## Product Change Notification: CENO-05FVJZ634

CCB 7084 Final Notice: Qualification of new stamped lead frame with inner lead tape and non-brown oxide treatment (non-BOT) for selected products available in 100L and 64L TQFP (14x14x1mm) packages at MMT assembly site.

**CCB 7084**  
**Pre and Post Change Summary**  
**PCN #: CENO-05FVJZ634**

| Pre change   | Post Change  |
|--|--|
| <i>100L TQFP (14x14x1mm) 280x280 mils</i>  |  |

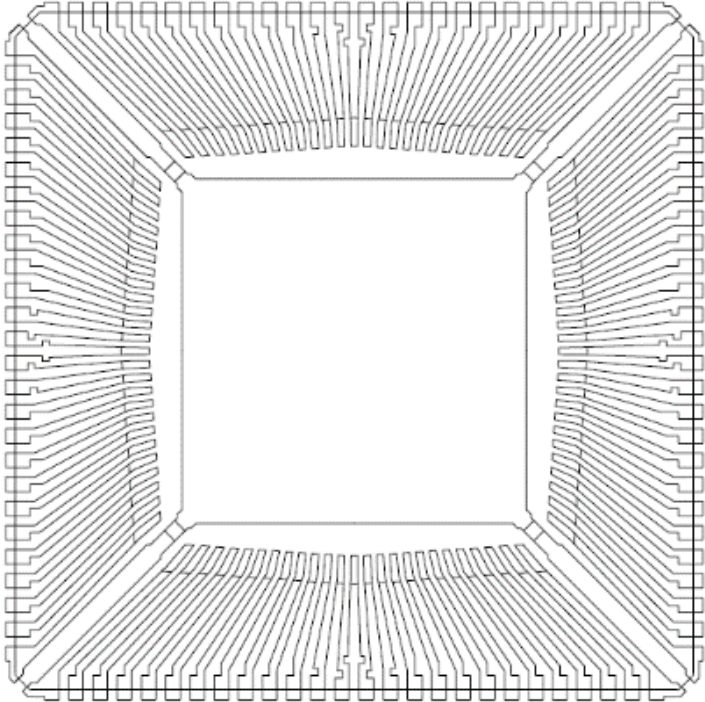
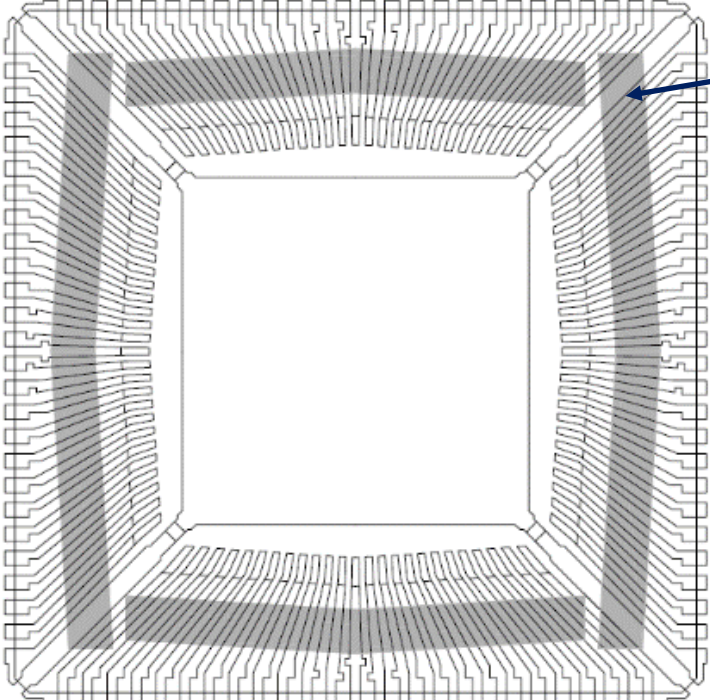
| Pre change   | Post Change  |
|--|--|
|  <p data-bbox="300 1158 970 1210">LF Treatment   brown oxide treatment (BOT)</p> |  <p data-bbox="2211 486 2390 572">with inner lead tape</p> <p data-bbox="1442 1158 2193 1210">LF Treatment   Non-brown oxide treatment (non-BOT)</p> |

| Pre change   | Post Change                         |                             |  |              |                                     |
|--|-------------------------------------|-----------------------------|--|--------------|-------------------------------------|
| <p>100L TQFP (14x14x1mm) 240x240 mils</p>  |                                     |                             |  |              |                                     |

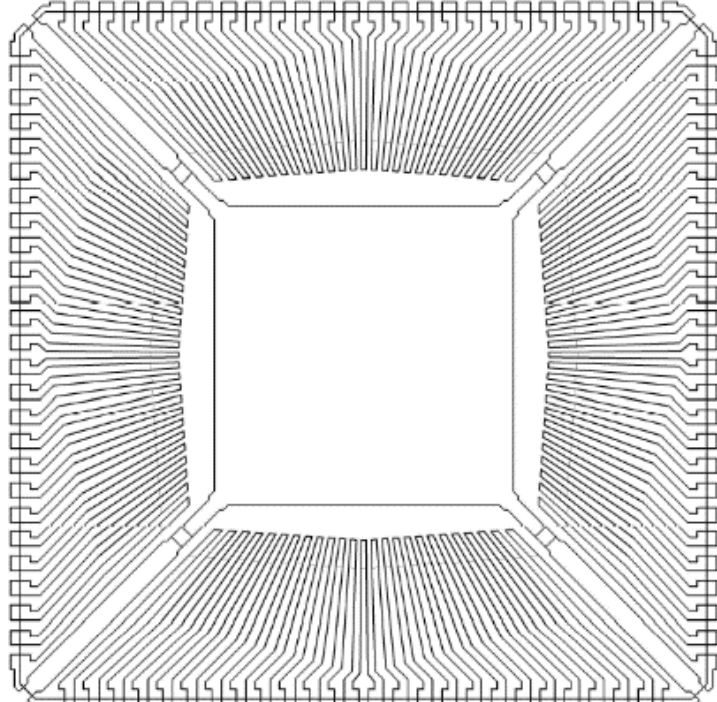
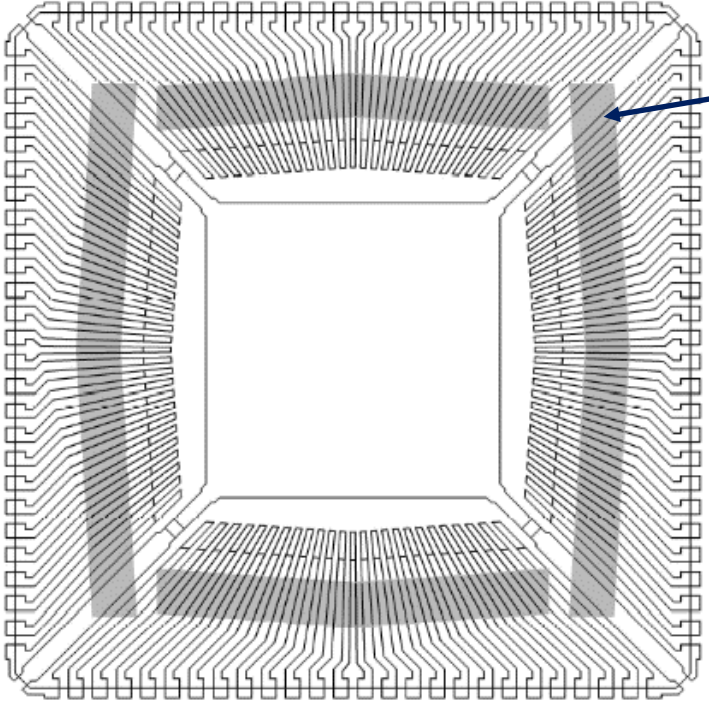
| Pre change   | Post Change                         |                             |  |              |                                     |
|--|-------------------------------------|-----------------------------|--|--------------|-------------------------------------|
| LF Treatment   | brown oxide treatment (BOT)         |                             |  |              |                                     |
| LF Treatment   | Non-brown oxide treatment (non-BOT) |                             |  |              |                                     |

| Pre change  | Post Change                         |                             |   |              |                                     |
|---|-------------------------------------|-----------------------------|---|--------------|-------------------------------------|
| <i>64L TQFP (14x14x1mm) 220x220 mils</i>  |                                     |                             |   |              |                                     |

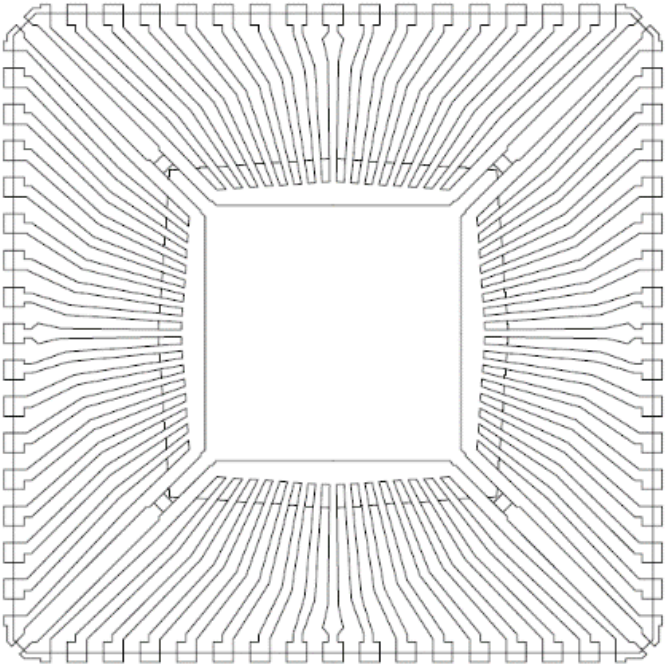
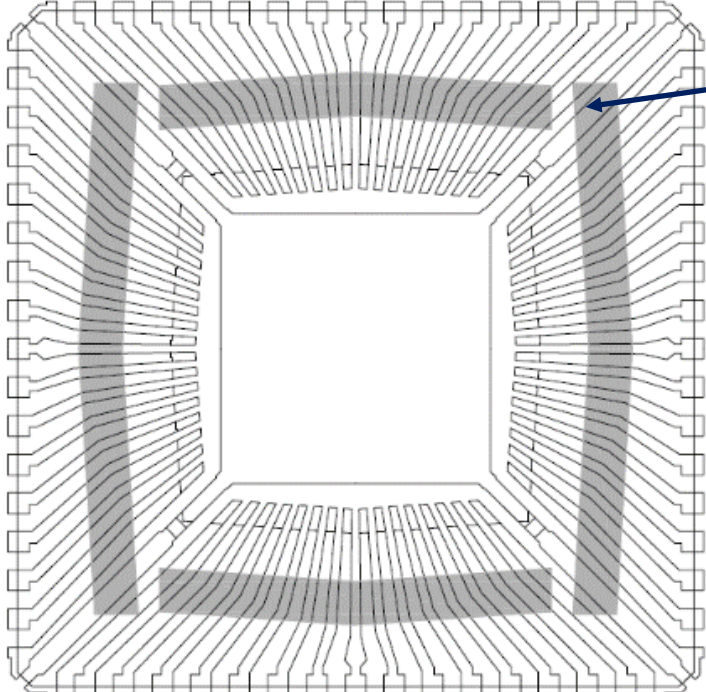
| Pre change  | Post Change                         |                             |   |              |                                     |
|---|-------------------------------------|-----------------------------|---|--------------|-------------------------------------|
| LF Treatment  | brown oxide treatment (BOT)         |                             |   |              |                                     |
| LF Treatment  | Non-brown oxide treatment (non-BOT) |                             |   |              |                                     |

| Pre change  | Post Change   |
|---|---|
| <i>100L TQFP (14x14x1mm) 280x280 mils</i>   |   |

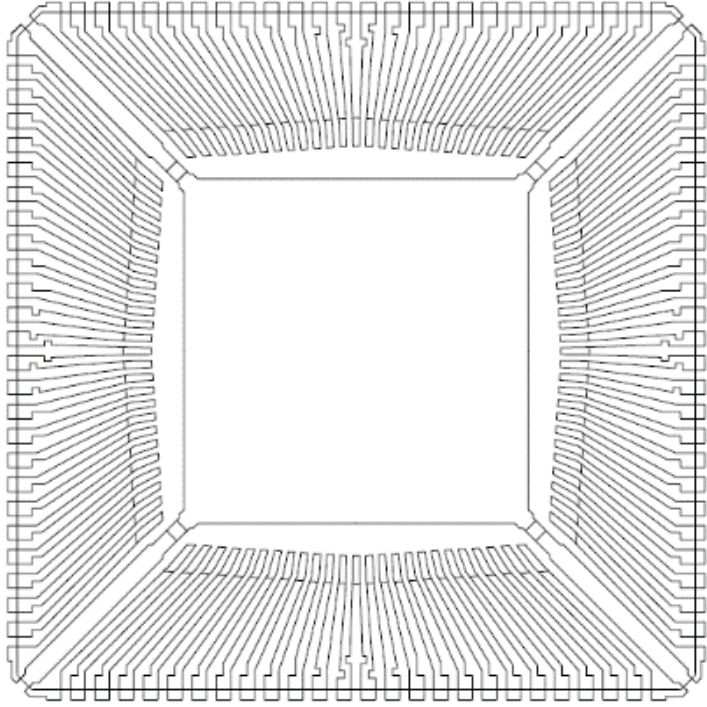
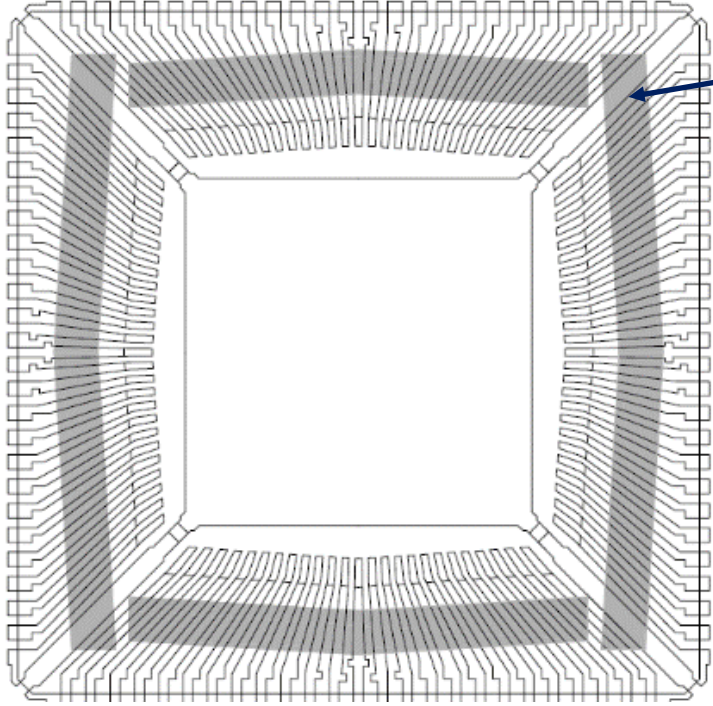
| Pre change  | Post Change   |
|---|---|
|  <p data-bbox="300 1158 973 1210">LF Treatment    brown oxide treatment (BOT)</p> |  <p data-bbox="2211 486 2390 572">with inner lead tape</p> <p data-bbox="1442 1158 2196 1210">LF Treatment    Non-brown oxide treatment (non-BOT)</p> |
